Docket Item #8 A&B

CDD CONCEPT DESIGN PLAN #2006-0001(A)
DEVELOPMENT SPECIAL USE PERMIT #2005-0041(B)
MOUNT VERNON COMMONS (TRIANGLE SITE)

Planning Commission Meeting
December 5, 2006

REQUEST: Consideration of a request for: 1) approval of a concept design plan and approval of an increase in floor area ratio with the provision of affordable housing; 2) approval of a development special use permit, with site plan, to construct a residential building with ground floor uses, as well as approval of an FAR increase and for a reduction in the parking and loading space requirement.

FIG 20: Attachment #1 - Cross-Section through Commonwealth Avenue and Walls on Public Open Space

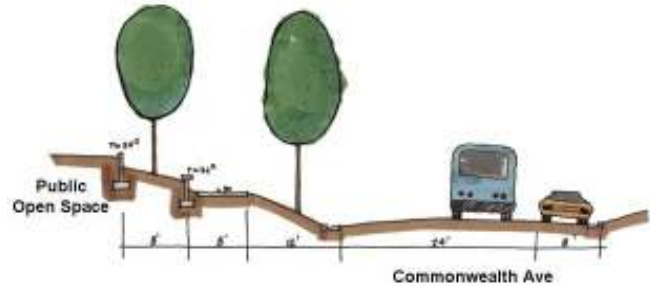
One of the big challenges with the creation of open space at this corner is the change in grade from Mount Vernon to Commonwealth Avenue as well as the associated pedestrian crosswalk at the corner of Mount Vernon Avenue and Commonwealth Avenue. The change in grade requires a 3 to 5 foot retaining wall adjacent to the sidewalk. In addition, at this corner, right hand turns onto northbound Mount Vernon Avenue are a difficult turning movement for vehicles. To address these issues staff recommends that the right-hand turn lane from Commonwealth Avenue to Mount Vernon Avenue be eliminated replaced with open space and landscaping to make the pedestrian environment more attractive, useable and reduce the length of the crosswalk across Commonwealth Avenue. This will likely minimize the need for retaining walls and enable approximately 2,000 sf to be visually added to the corner open space, although the area will remain public right-of-way.

7. The open space area at the intersection of Mount Vernon and Commonwealth Avenues shall provide the level of detail and amenities depicted on the preliminary plan and shall also provide amenities such as special paving surfaces, materials, benches, trash receptacles, landscaping, etc. to encourage its use. In addition the open space shall be revised to provide the following to the satisfaction of the Director of P&Z:

FIG 21: Attachment #2 - North End Open Space

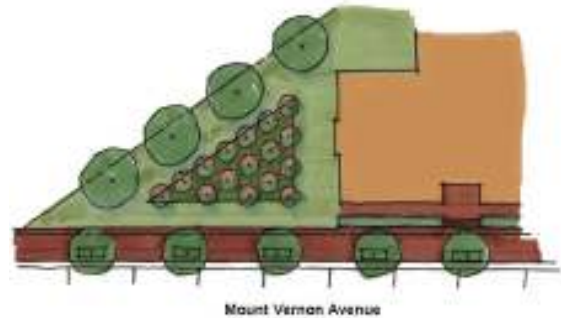
A second open space area will be built at the north end of the site, adjacent to Mount Vernon Avenue. The space is approximately 3,000 sf and a circular brick paver sitting area has been provided with sporadic landscaping. Staff is recommending that the space be simplified with a series of trees that reinforces the triangular shape of the space and the site.

FIG 22: Attachment #3 - Central Courtyard Area

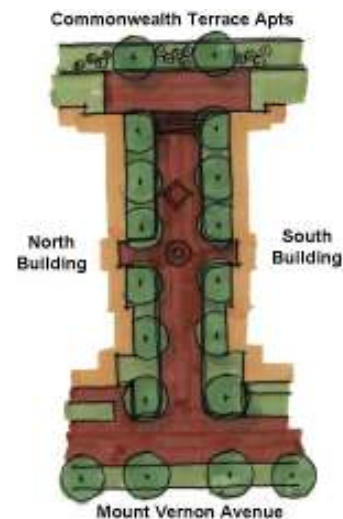
One semi-private open space area has been provided in the middle of the project, at the axis of Kennedy Street. This open space also serves as a mid-block building break with a pergola at the entrance and is visible from Mount Vernon Avenue. The space has special paving, benches, raised planters and landscaping. Staff is recommending that the space be modified to eliminate the pergola and provide upright trees in the space to provide a more visually open green space as a green visual extension of Kennedy Street as previously discussed. Staff is also recommending that the raised planter at the end of the courtyard be eliminated and that steps be provided to the terrace on the east side of the building with a sitting area provided on the terrace.

- b. The central courtyard shall be revised to provide less hardscape and paving to be a green landscaped extension of Kennedy Street with small shade trees in planters such as River Birch or Thornless Honeysuckle as generally depicted in *Attachment # 3*. The planter at the end of the courtyard shall be removed and a stairway shall be provided to connect the courtyard with the terrace below, which shall have special paving, benches, lighting and landscaping.

Attachment #4

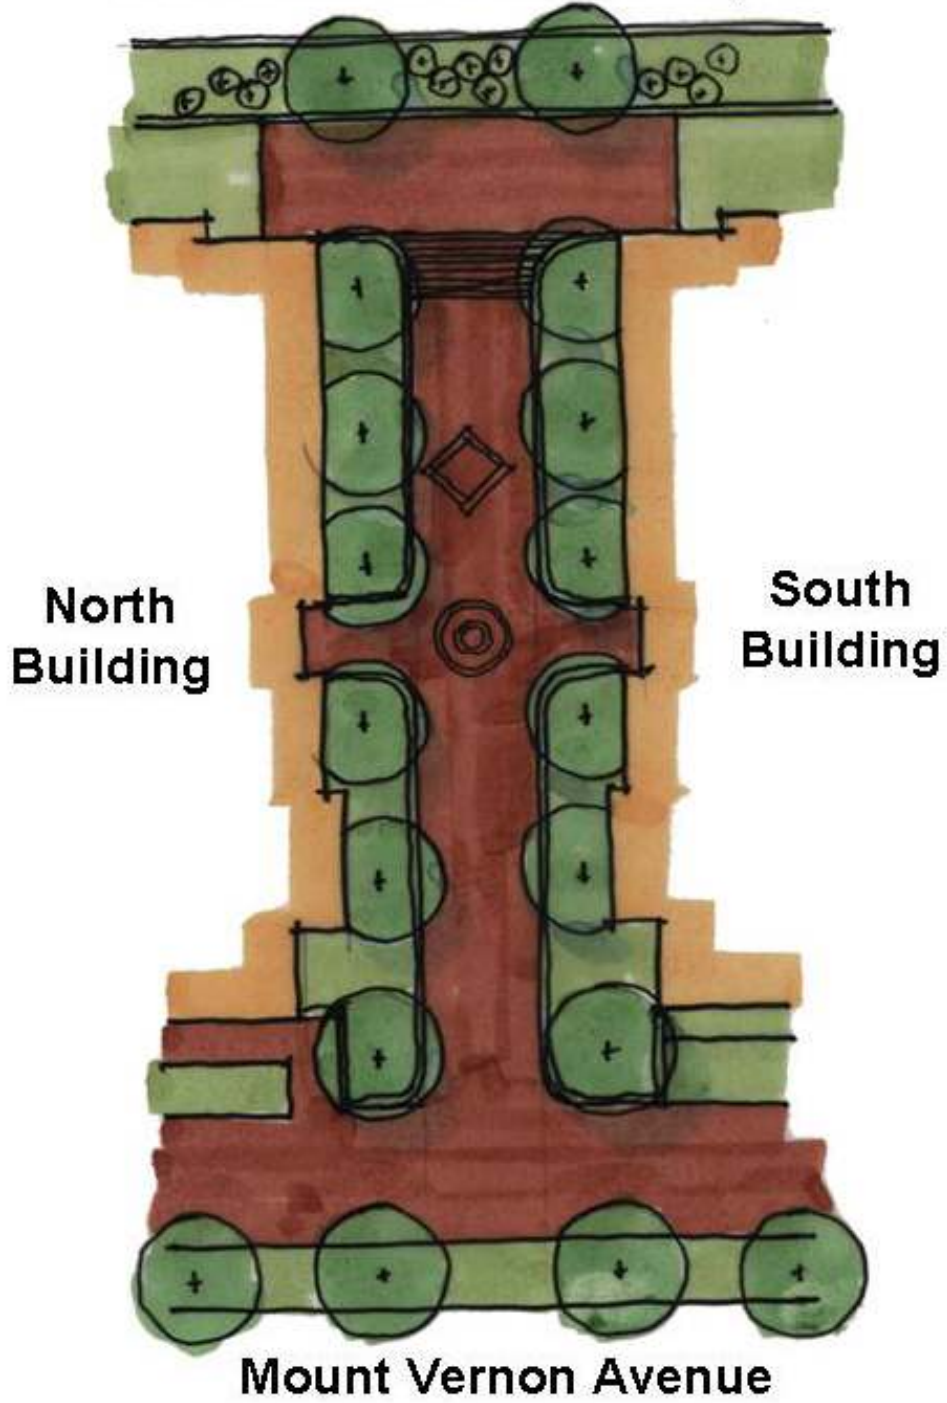
- d. The portion of the building with the green metal bays shall be revised to provide the following:
 - i. A lighter color cornice located as generally depicted in Attachment #4.
 - ii. The retaining wall adjacent to Mount Vernon Avenue shall be revised to be the same color brick as the adjoining building. The wall shall also introduce vertical elements to reduce the perceived length of the wall.
 - iii. The metal bays shall provide additional detail and articulation.
- e. The center “building” shall be revised to have three pavilions to vary the roof height as generally depicted in *Attachment # 4*.
